New Model Introduction

New model GR-4020 is offered as a replacement for model GR-3520V. Models have common mounting and tooling and are dimensionally the same except as shown.

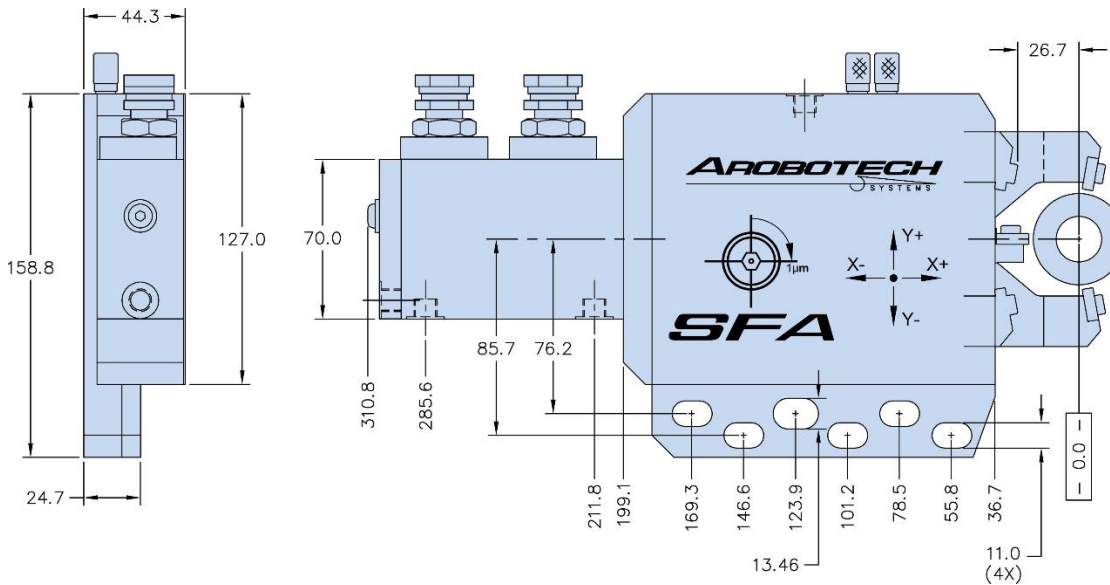
Gen 4 Model GR-3520V

- * 15 to 35mm Diameter
- * 6.4 cm² Piston Area
- * X-Axis = 3.1° Turn = 0.001mm Adjustment ▪ ±0.22mm Total Adjustment
- * Y-Axis = 10.4° Turn = 0.001mm Adjustment ▪ ±0.07mm Total Adjustment

Gen 5 Model GR-4020

- * 15 to 40mm Diameter
- * 6.4 cm² Piston Area
- * 90° Turn = 0.001mm Adjustment (both axis)
- * +/- 0.200mm Total Adjustment (both axis)
